SS 3175-FTL Progressive Low Voltage Disconnect Parameter Update

New Cascadia vehicles built between July 1st, 2021 and February 5th, 2025.

M2+ vehicles built between January 9th, 2023 and February 5th, 2025.

Issue

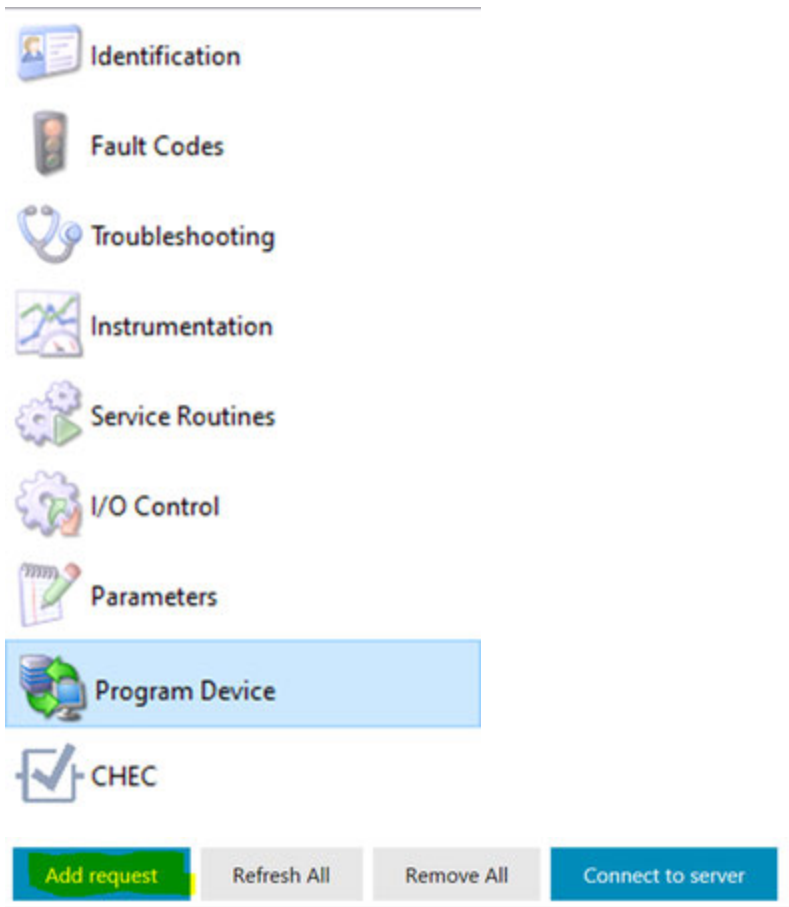
While the vehicle is shut off and parked for extended periods the batteries are protected from over discharge with the Progressive Low Voltage Disconnect feature. Due to an error in a feature parameter which wakes up the ASAM periodically to check battery voltage, the feature did not work as intended. This error caused failure to disconnect specific loads from the power supply causing batteries to over discharge.

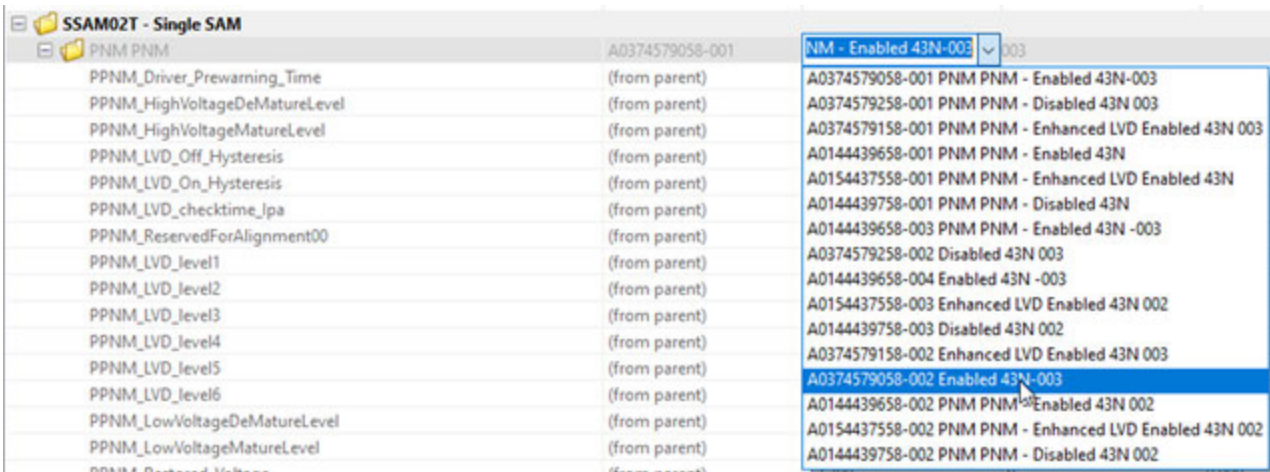
5. Select the part number below in the drop down menu for the PNM group as shown below. **The selection needs to be the next revision of the currently equipped parameter. Please see table below for reference.**

Example: A0374579058-001 Enabled 43N-003 → A0374579058-002 Enabled 43N-003

6. Verify the adjusted parameters are showing the correct values. If matching the values below, click **Send**.

Note: These two parameters are the ONLY adjustments.

PPNM_LVD_checktime_lpa = 10

PPNM_ReservedForAlignment00 = 0
